PUBLIC WORKS CONTRACT (Formal Bid)

Monterey Conference Center Solar PV Project (30c1453)

Figure 3: Cross Sectional Diagram of the Monterey Conference Center Upper Roof (REVISED PER ADDENDUM 1)

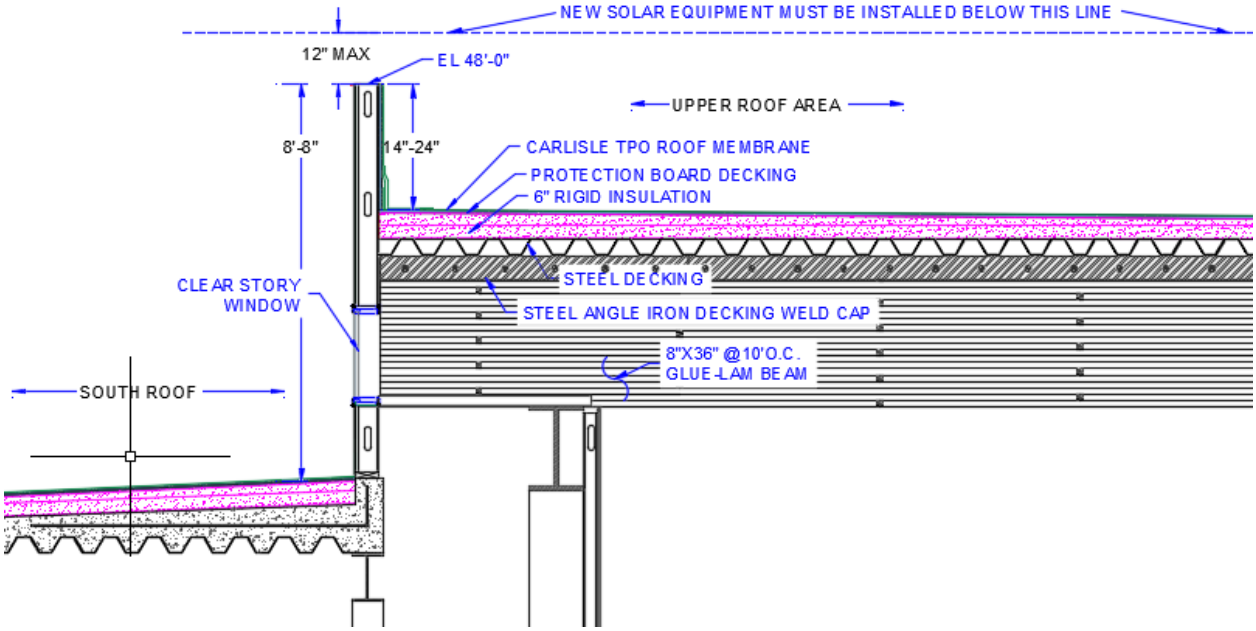
ITEM 6: VISIBILITY
In accordance with Part I, Page 1, rooftop solar equipment shall minimize it's visibility from the ground. The engineer shall be the sole judge as to what constitutes minimizing visibility from the ground. Figure 3 on Part IV, Page 25 is amended as shown below to increase the height limit for the rooftop solar equipment to 12" above the parapet wall. Inverters and other solar equipment may be mounted on the roof provided they adhere to the visibility requirements.
